Exchange of control panel brackets with new ones

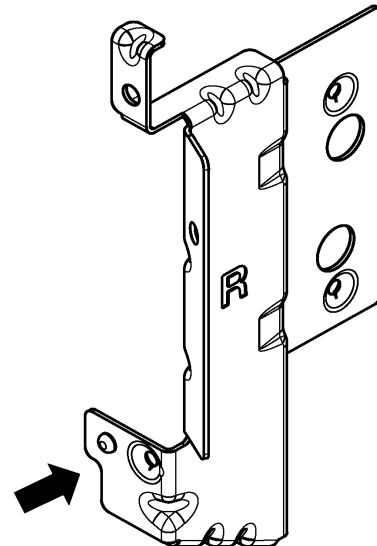
In ovens, construction of control panel brackets has been modified. One of the mounting holes has been replaced by a clew. As a result, old type of bracket required two screws to mount the component to the front frame, new type of bracket requires only one screw.

Old bracket

New bracket

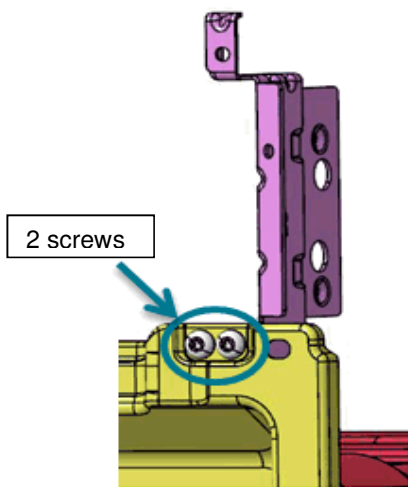
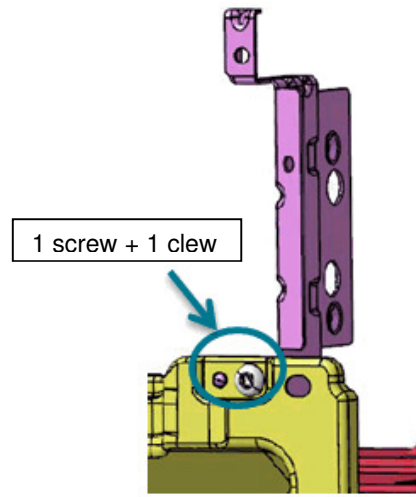
Current component

New solution

In case of new bracket damage, replace with new bracket. In case of old bracket damage, both possibilities can be fitted correctly.

The above way of repair is valid for all PNCs which are equipped with above control panel brackets, but from production week 10/2016 (serial number 610xxxxx) onward only replacement with new bracket is allowed.
